# DEVELOPMENT REVIEW BOARD REPORT

SUBJECT	<b>Redbird Property (formerly Redbird 75 Acres) 25-PP-2004</b>
REQUEST	<p>Request approval of Preliminary Plat for 17 single-family residential lots with amended development standards, as well as an entry feature, screen wall, and gatehouse on an 81-acre parcel.</p> <p><b>Related Policies, References:</b> General Plan: Trails Master Plan, Environmental Sensitive Lands Ordinance.</p>
OWNER	Brian MacDonald
APPLICANT CONTACT	Steven Voss LVA Urban Design Studio LLC 480-994-0994
LOCATION	Northwest Corner of North 118 <sup>th</sup> Street and the East Redbird Road Alignment
BACKGROUND	<p><b>Zoning.</b> The site is zoned Single Family Residential District with Environmentally Sensitive Lands Overlay (R1-190 ESL). The zoning district is intended for large lot single-family residential dwelling units.</p> <p><b>Context.</b> The proposed subdivision is located at the northwest corner of North 118<sup>th</sup> Street and the east Redbird Road Alignment. The Redbird Road Alignment is unimproved and inundated by rock outcroppings. The site is vacant, undeveloped, and contains generally undisturbed Upper Sonoran Desert vegetation. The site has several s

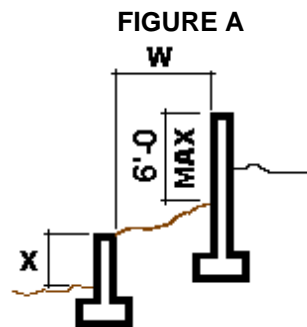
22. All walls shall match the architectural color, materials and finish of landscape feature walls exhibit submitted by LVA Design Studio dated 3/24/2006 by city staff.
23. Walls within a sight visibility triangle shall not exceed 2 feet, 0 inches measured from nearest street line as described in the DS&PM.
24. Any retaining wall and fence wall combination (a fence wall on top of a retaining wall) adjacent to streets, washes, open space, vista corridors, scenic corridors shall not have a visual height greater the 6-feet. Wall combinations that have a visual height greater than 6 feet, shall be stepped or broken up through the use of multiple retaining wall as shown Figure A.

The height of any individual retaining wall, within the stepped wall combination, shall not exceed a maximum of 6 feet, “x” dimension shown on Figure A. The separation between step walls, “w” dimension shown on Figure A, shall be a minimum of 4 feet when the lower retaining wall “x” has a visual height up to 4 feet. The minimum separation, “w” dimension shown on Figure A, shall be equal to the height of the “x” dimension when the visual height of “x” is greater than 4 feet
